## ADDENDUM NO. 04

<b>PROJECT:</b>	<b>Auburn Park Full Build-Out Montgomery County, VA Parks and Recreation</b>
<b>GNI Job No.:</b>	<b>2893.00</b>
<b>DATE:</b>	<b>Friday, March 15, 2024</b>

PROJECT TEAM	
PIC	TREVOR M. KIMZEY, PE
PM	MATTHEW P. TOMLINSON, PE
DESIGN	CPM
ISSUE DATE	
1/26/2024	
FDS JOB NO.	
ZMM 2023006	
SHEET TITLE	
EXTERIOR ELEVATIONS - RESTROOM BUILDING	
SHEET NUMBER	
A102

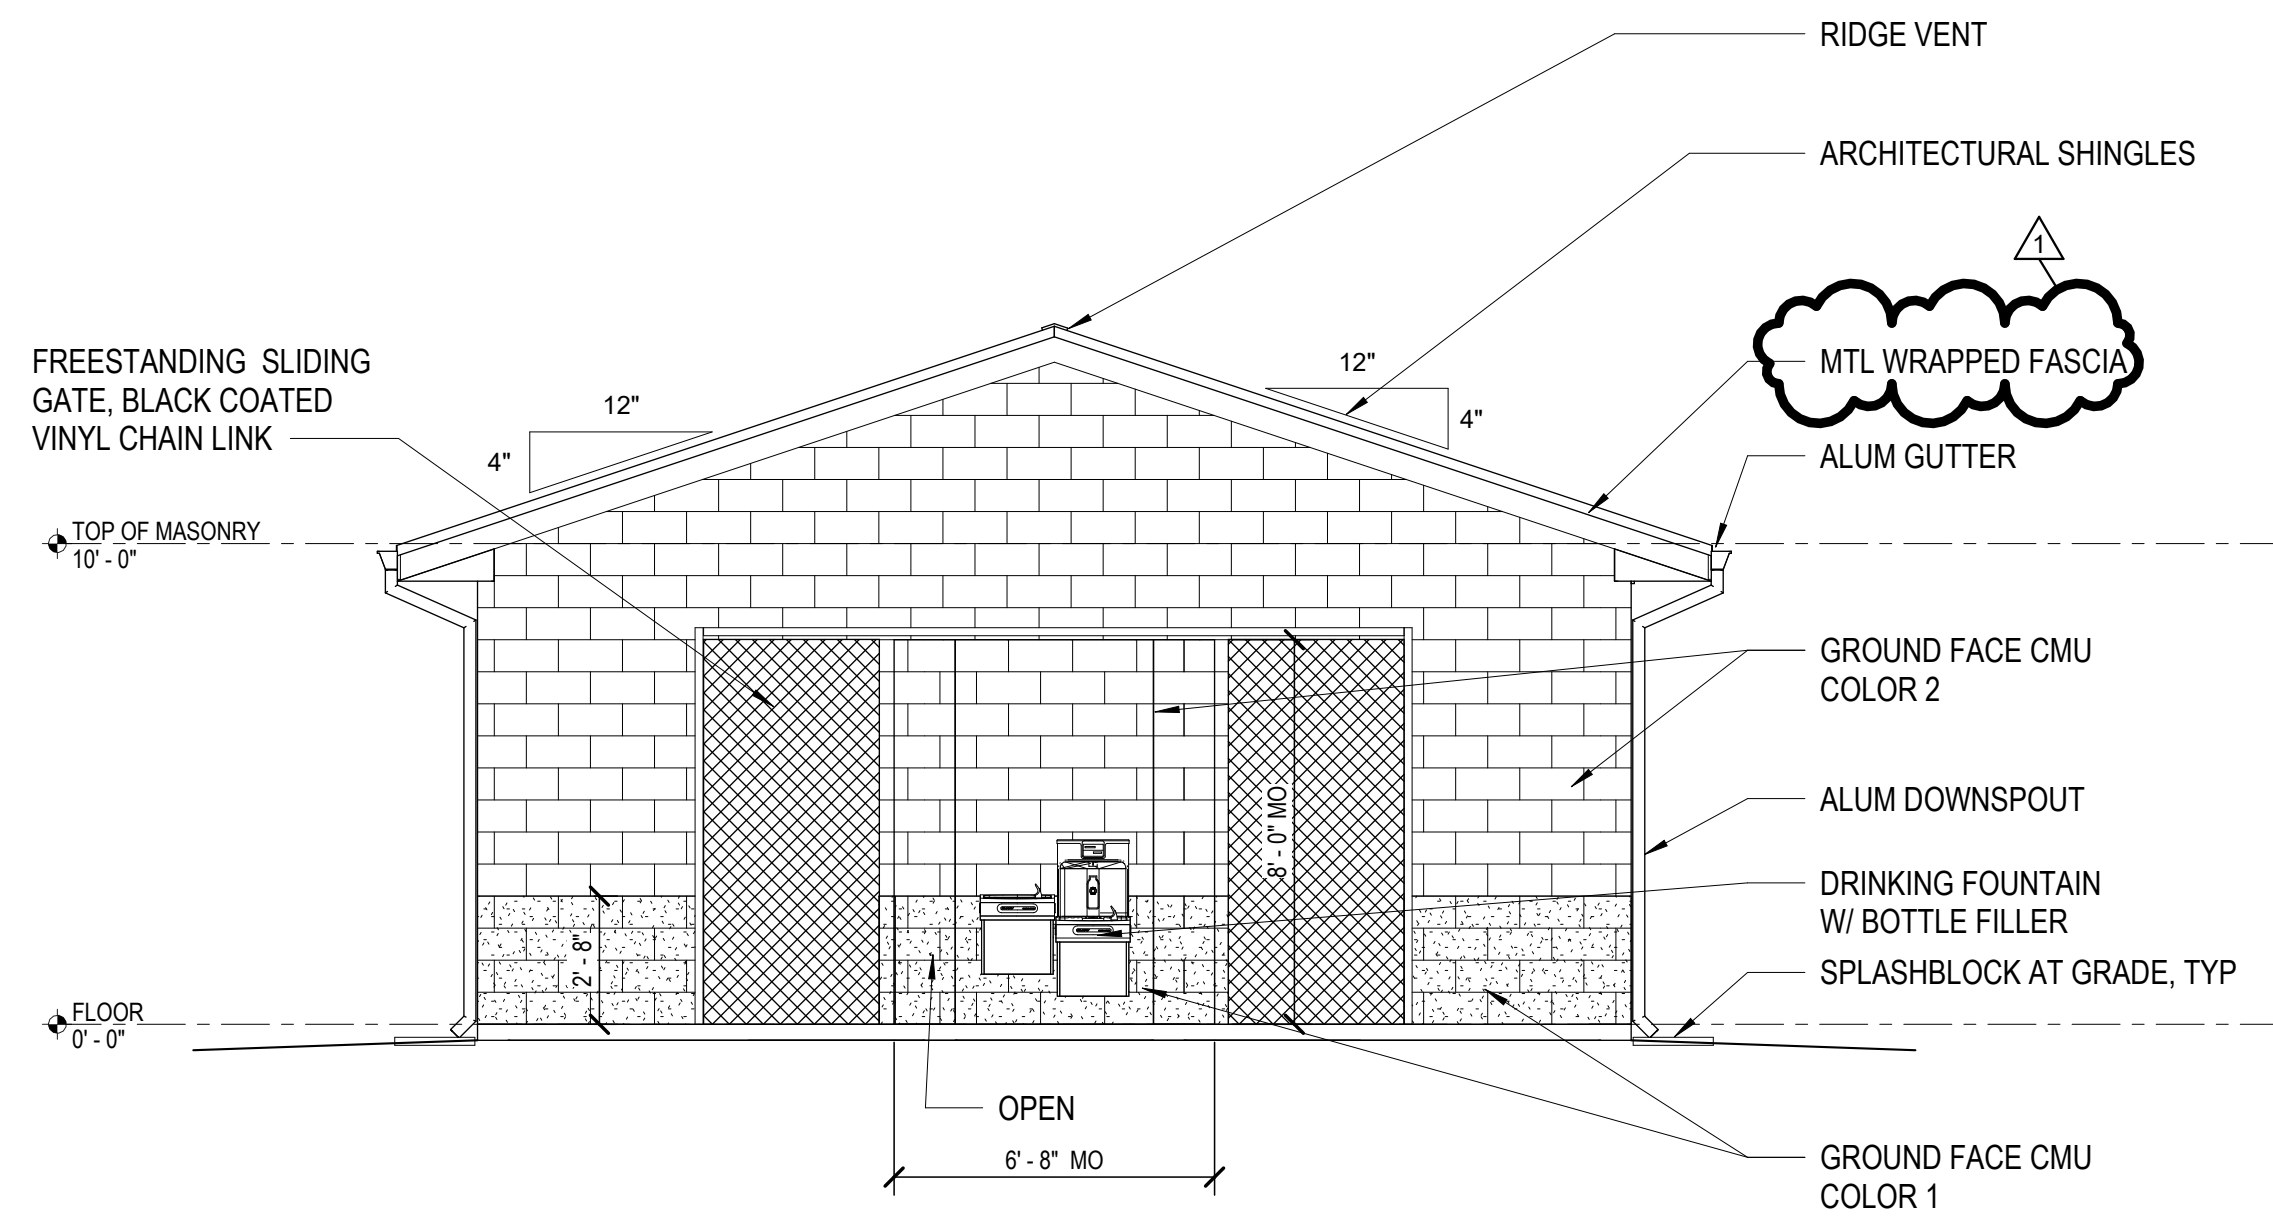
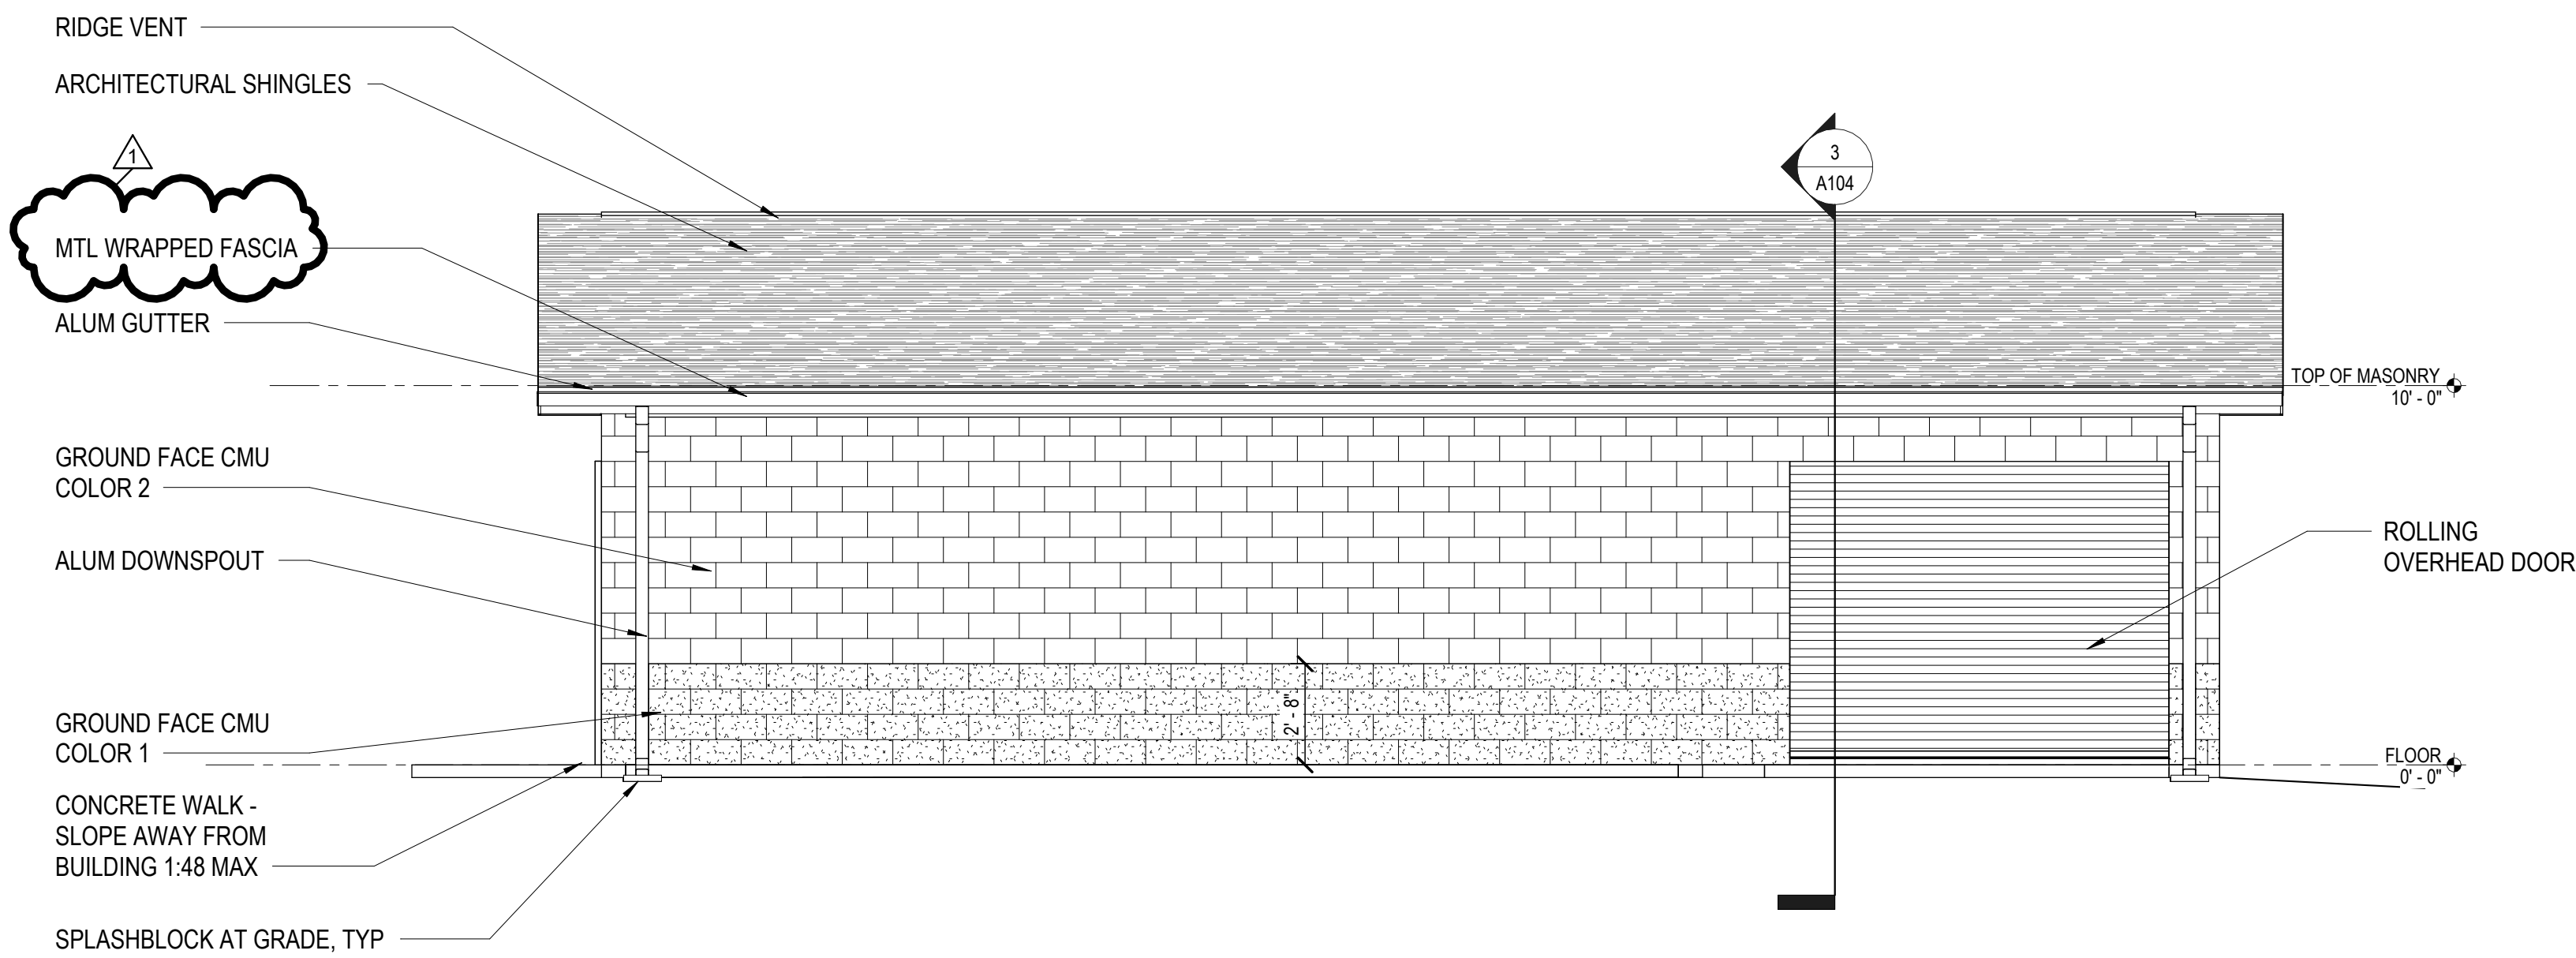
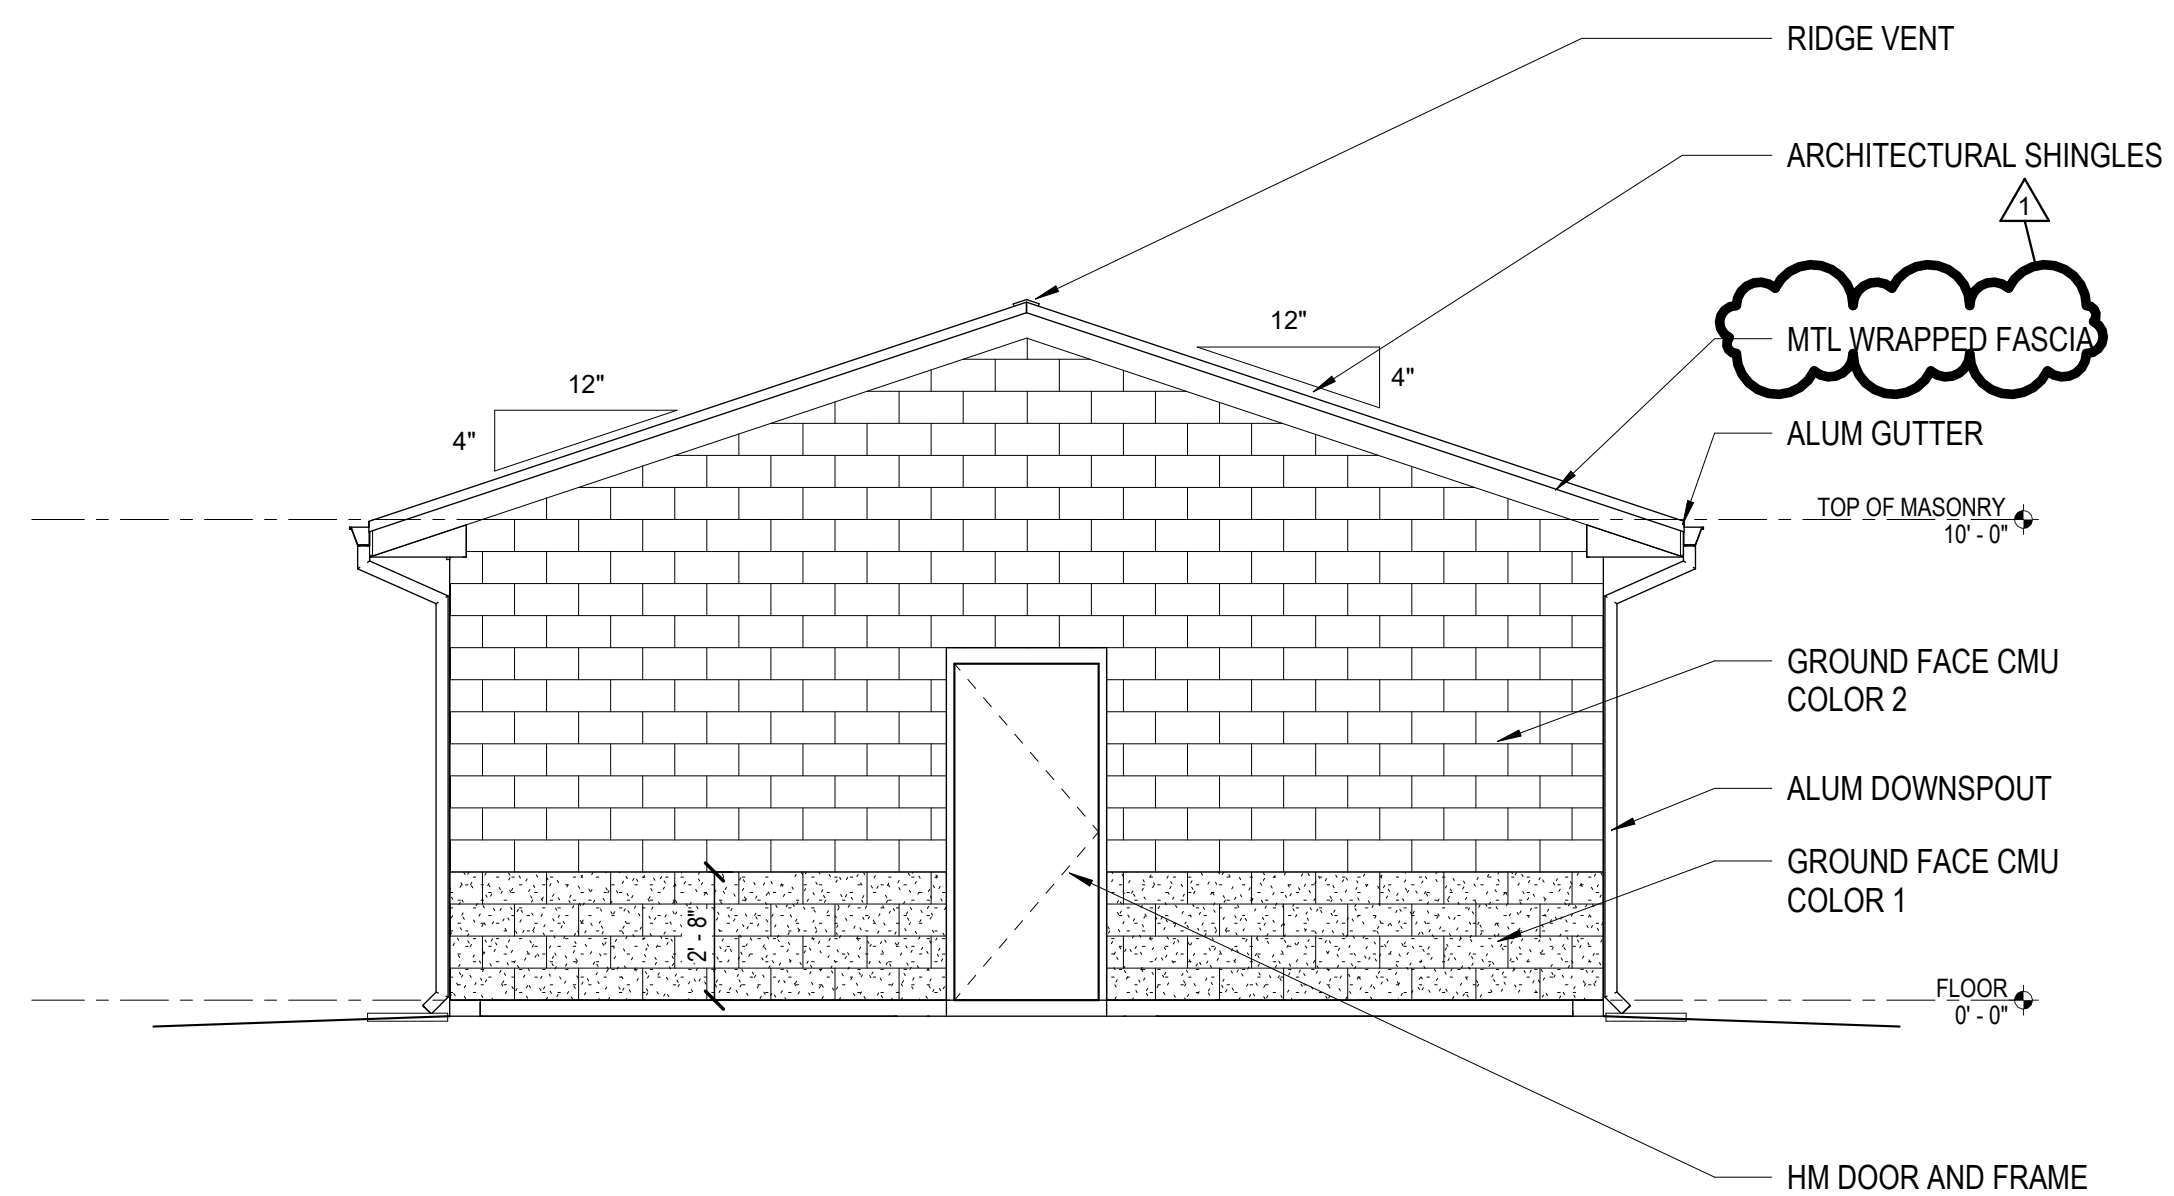
**REVISE** Labels calling for “PVC FASCIA” on all elevation views on this sheet to read as follows:  
“MTL WRAPPED FASCIA” as shown in attached revised Sheet A102 with revision date 3-14-24.
